REVIEW COMMENTS

FILE #MS-95-160

TITLE HEADING: Kain/Keenan Minor Subdivision

LOCATION: 2715 G Road

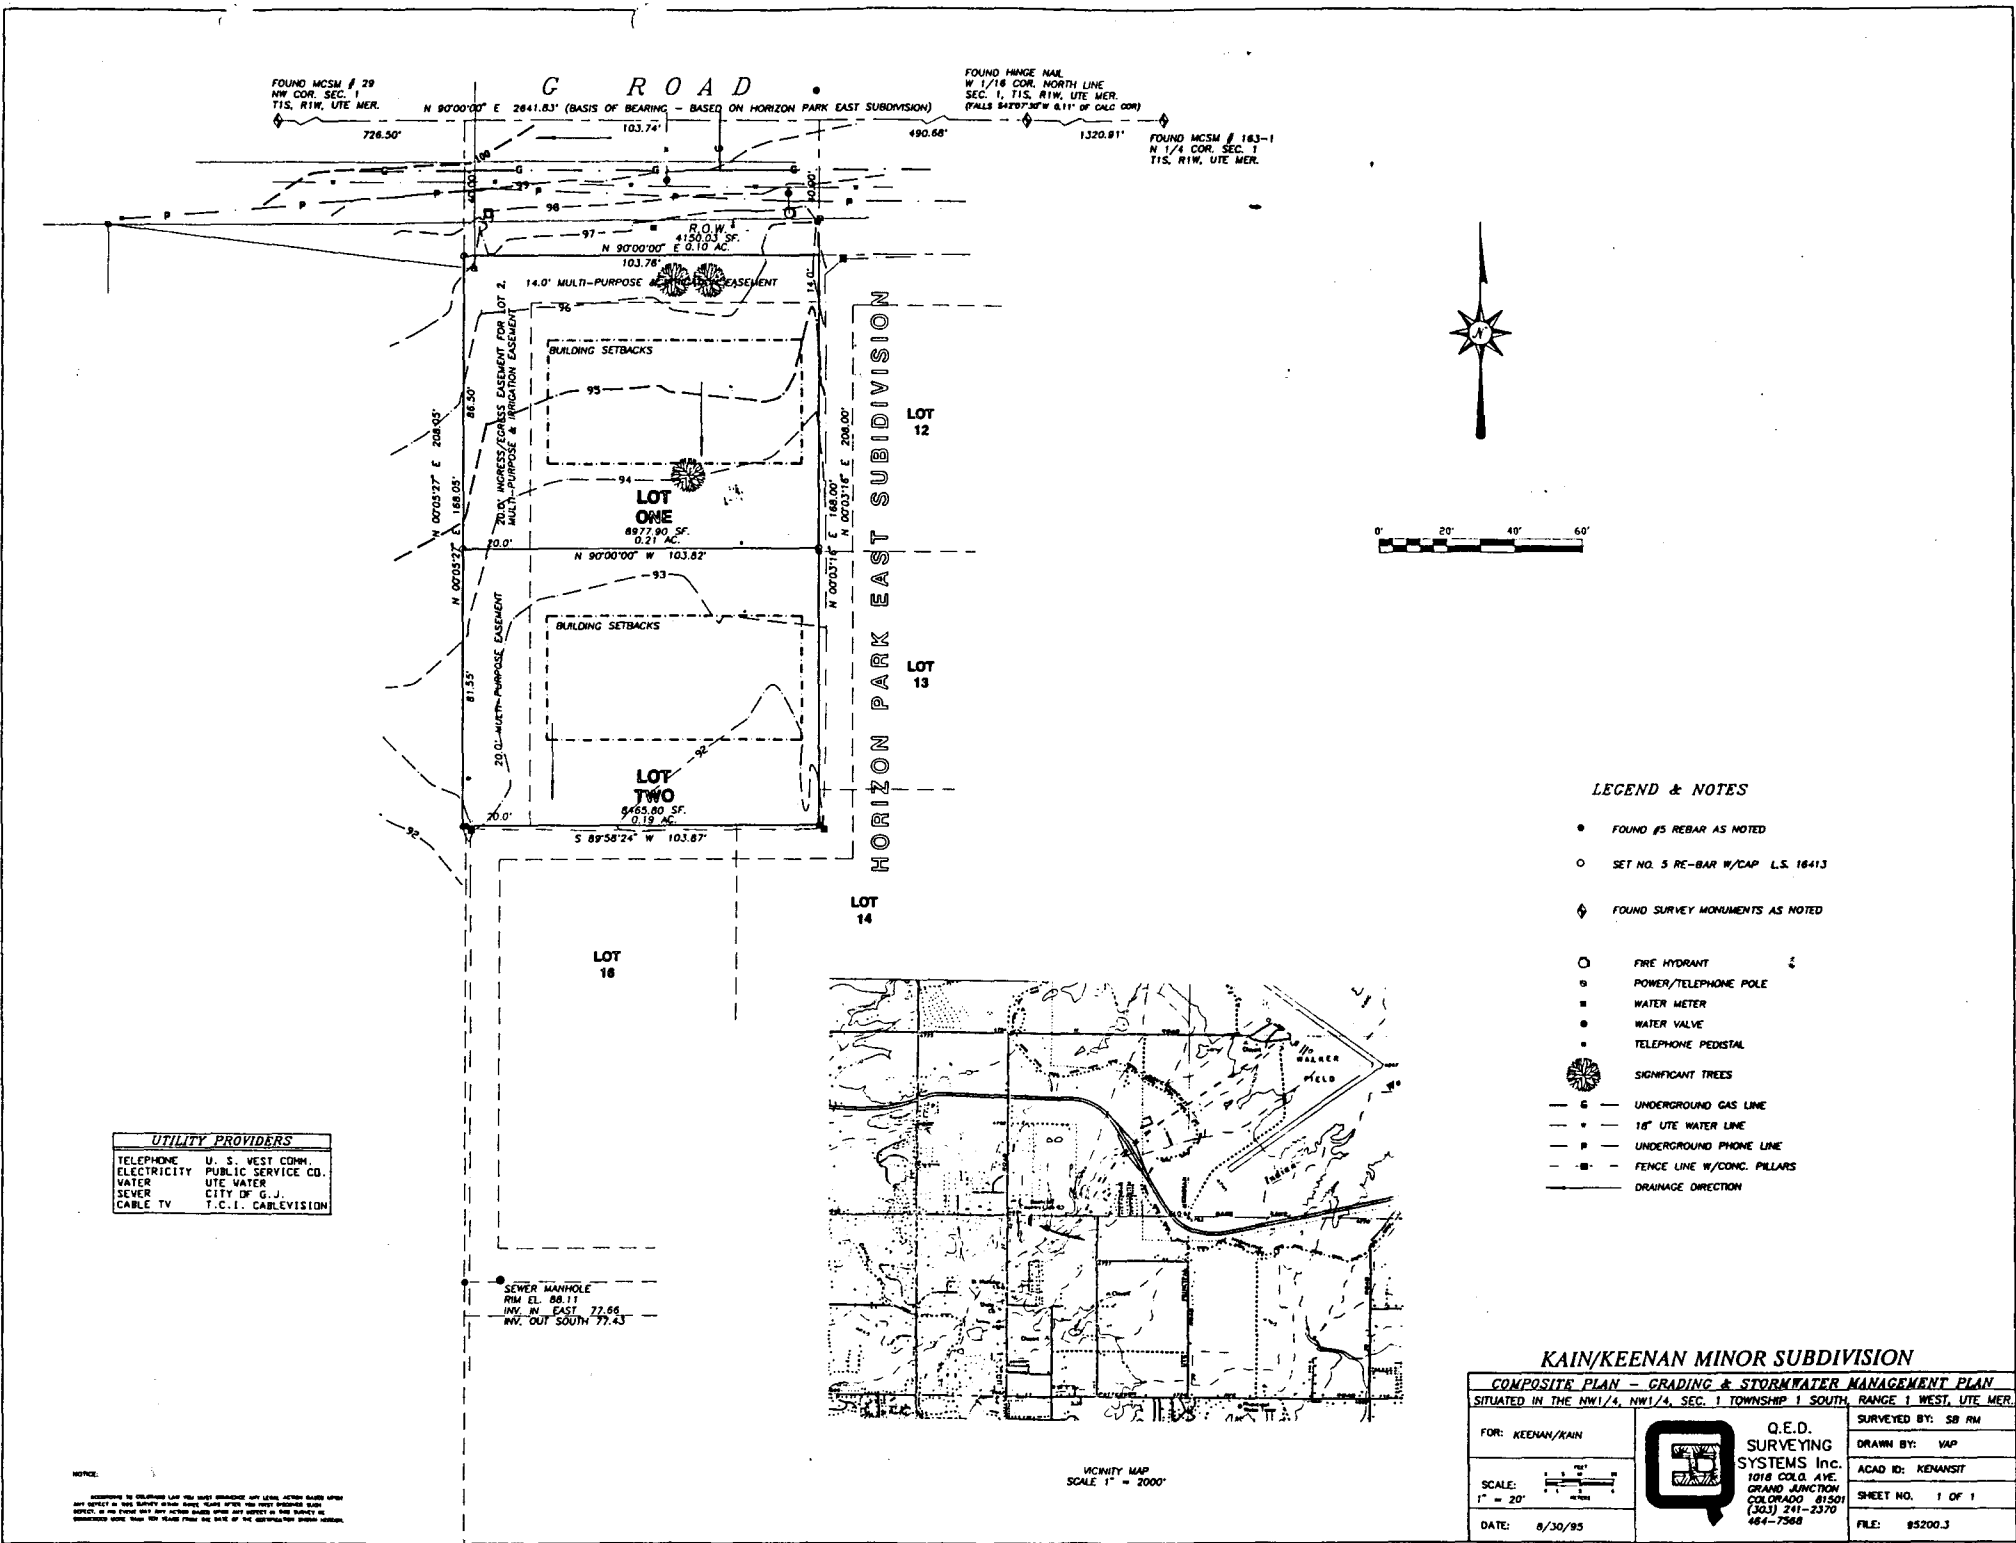
1. Lot 2 must be extended to have 20' of street frontage onto G Road. The ingress/egress easement does not satisfy Code requirements in Section 4-2-5-C-1.
2. Designate on the plat what will be the front, rear and side yards for Lot 2.
3. The front yard setback for Lot 1 is 65' since G Road is a minor arterial road. The building setback for Lot 1 on the site plan is correct.

1. A connection to sewer will be mandatory. Sewer is presently available through an existing easement across the westerly portion of the lot to the south of the proposed development. The approximate distance to the sewer is 100-120' from the southwest corner of proposed development.
2. As the sewer was installed by the developer of the Horizon Park East Subdivision, a sewer "payback" will be required prior to giving approval for the plat to be filed.

MS 95-160

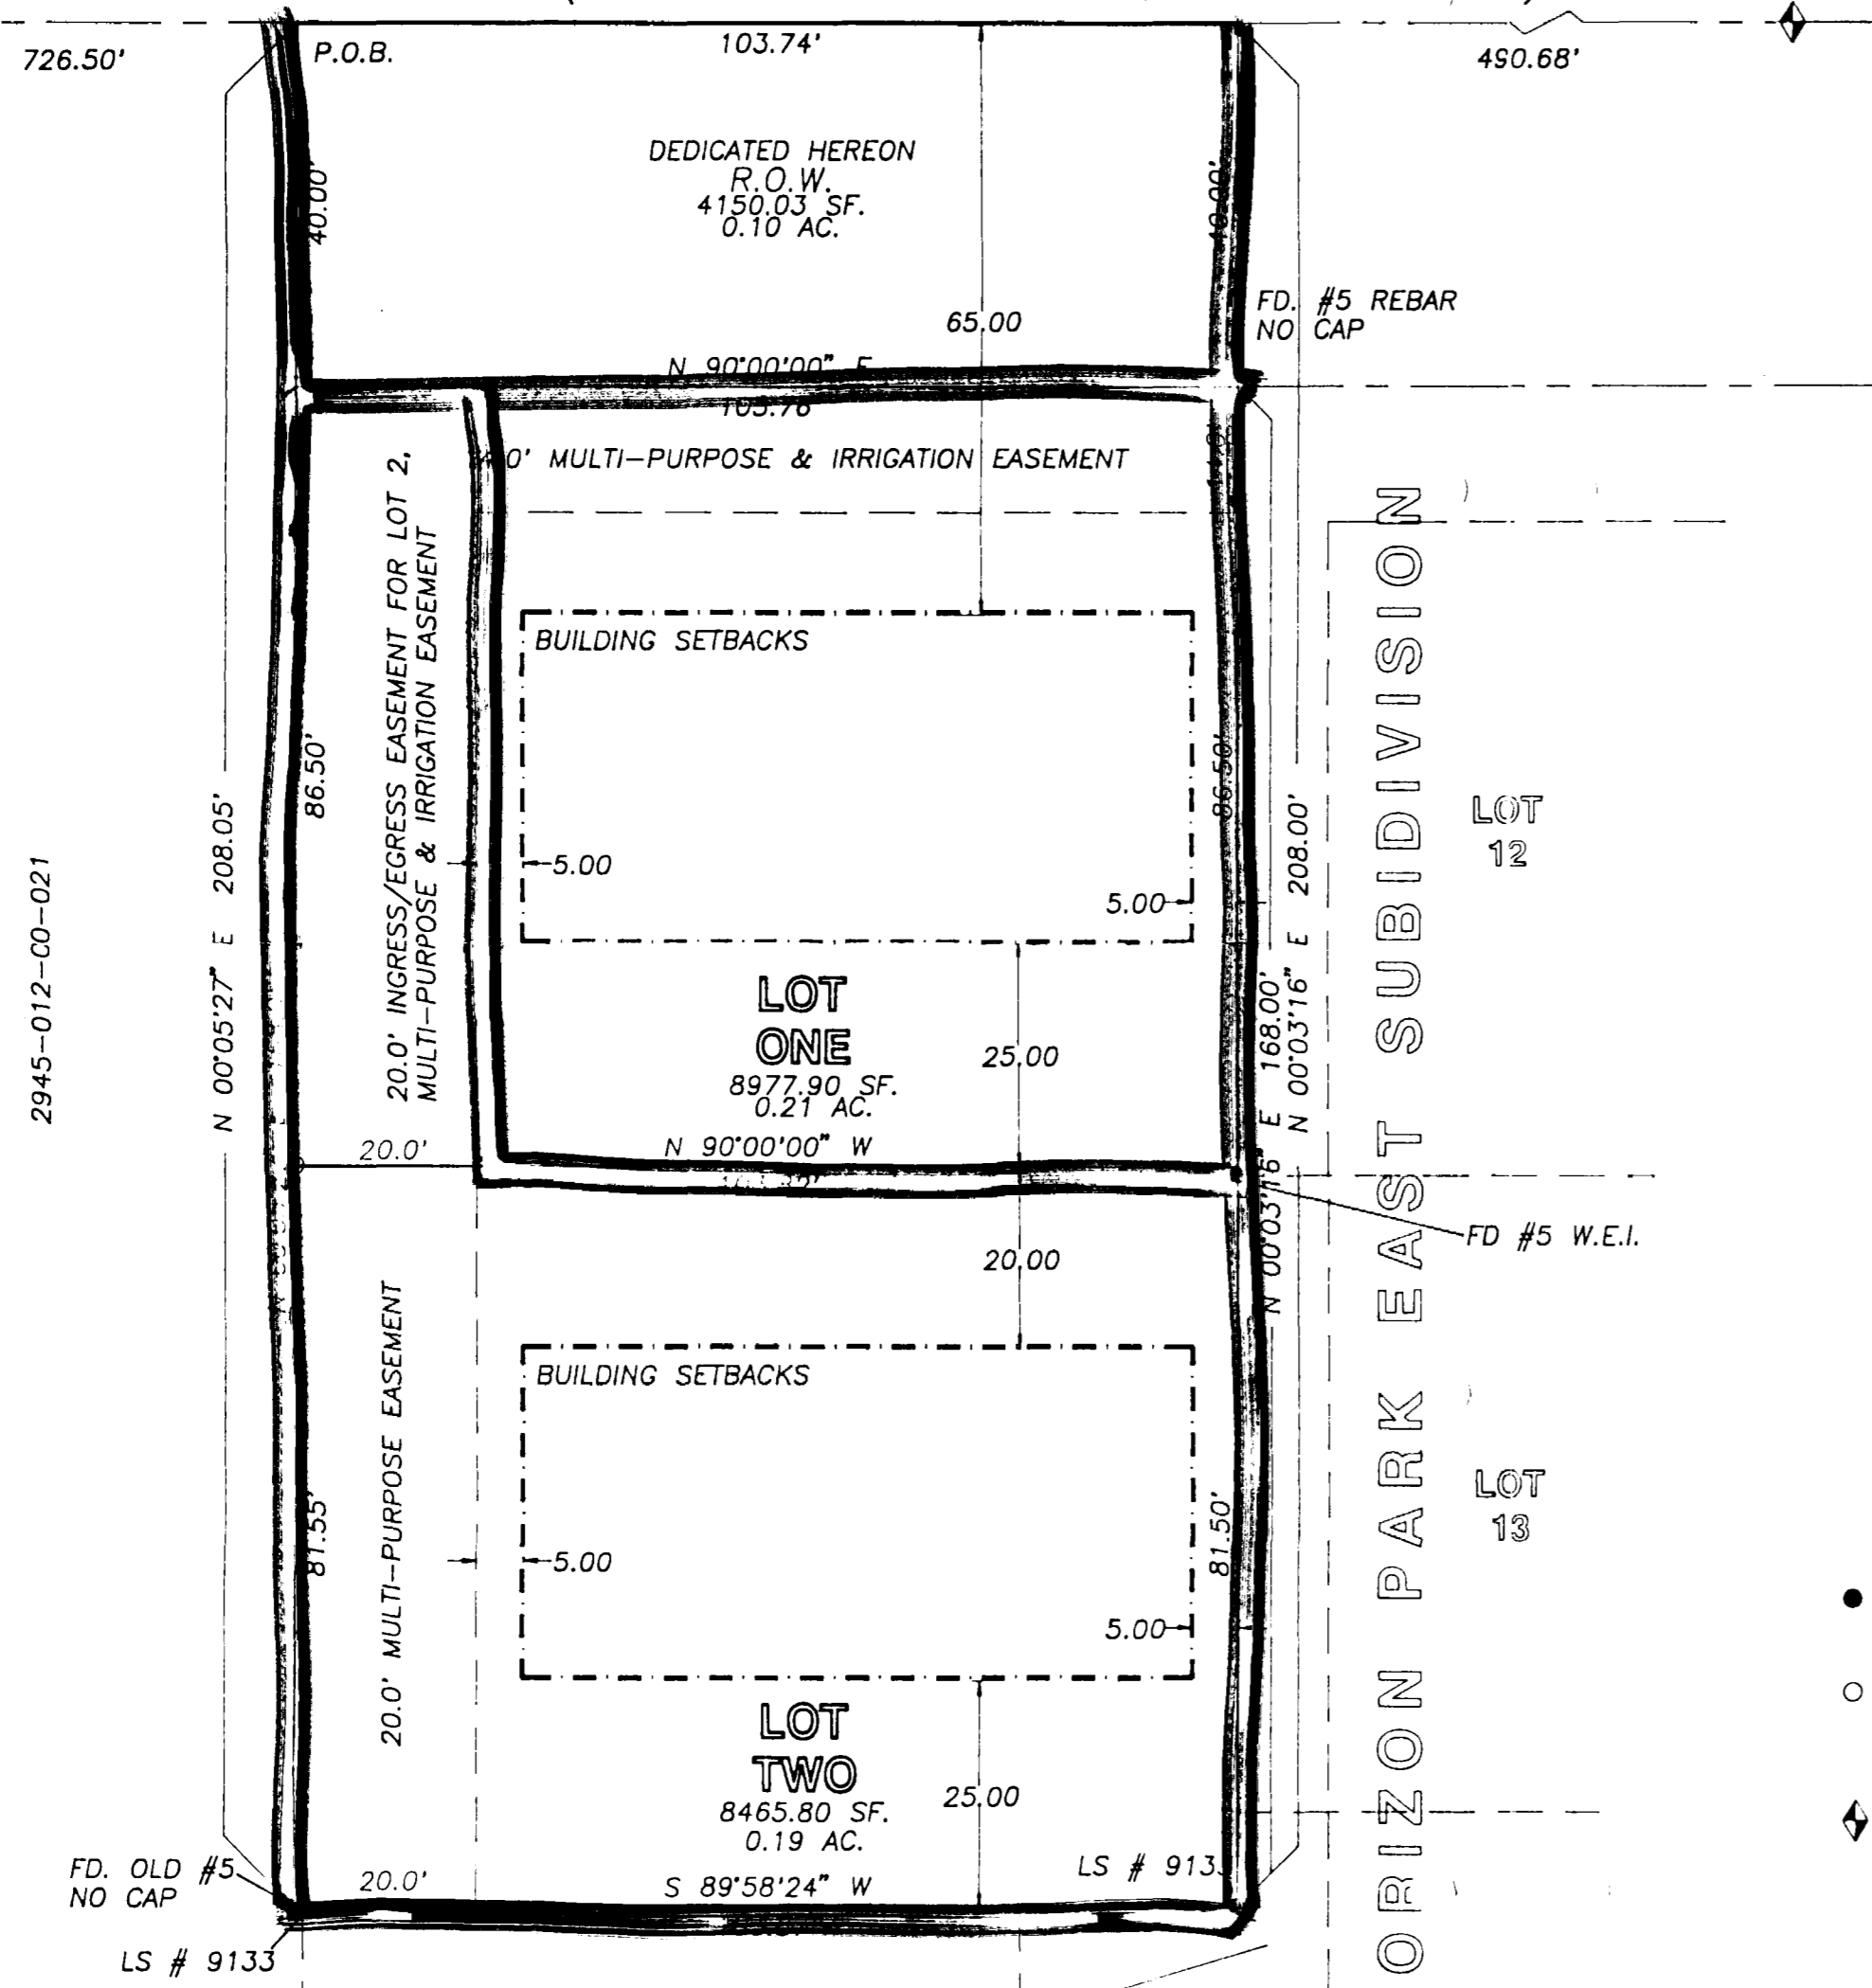
Although prior staff comments to the applicant requested that setbacks be shown on the plat for Lot Two, the final copy of the subdivision should show no setbacks. However an inset should be provided showing the location of the front, side and rear yards. No Covenants, Conditions and Restrictions (CCRs) have been submitted for this subdivision. The applicant has one year from final Planning Commission approval to record the subdivision plat.

3. Remove all references to building setbacks from the primary portion of the subdivision plat. An inset shall be included for information purposes that shows the location of the front, side and rear yard of lot 2. Setbacks are as shown on the resubmitted plat. No dimensions or building envelopes shall be shown.
